DRAWING A105

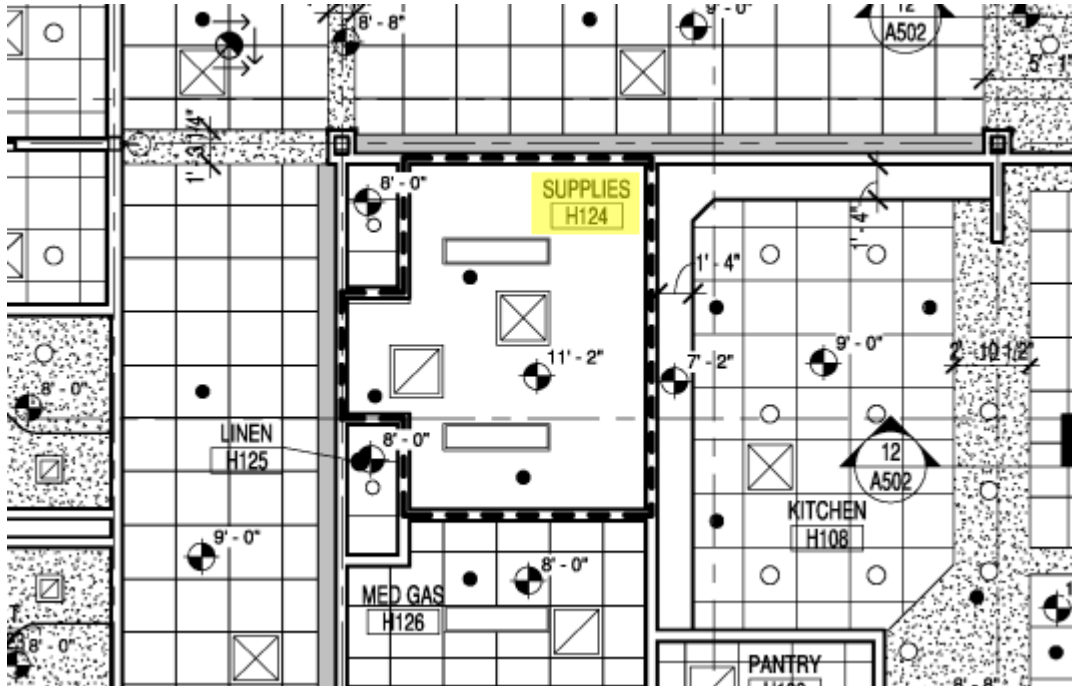
Question 12: Does supplies room H124 receive an acoustical ceiling as provided drawing A701 or gypsum ceiling as it appears on drawing A105?

Answer: It should be a 2x2 lay-in below the FR GWB barrier.

DRAWING A106

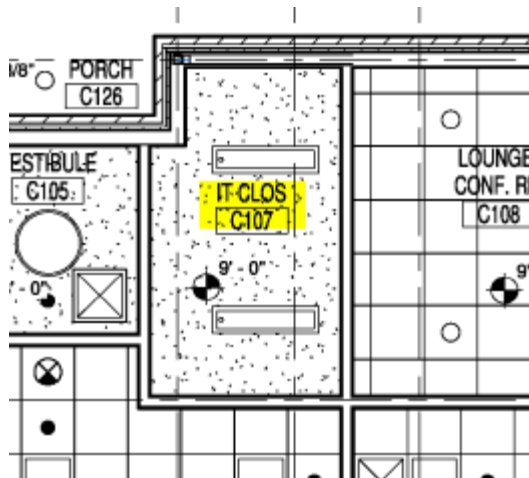
Question 13: Does it closet room C107 receive an acoustical ceiling as provided drawing A703 or gypsum ceiling as it appears on drawing A106?

Answer: **IT CLOSET C107 shall have a GWB ceiling.**
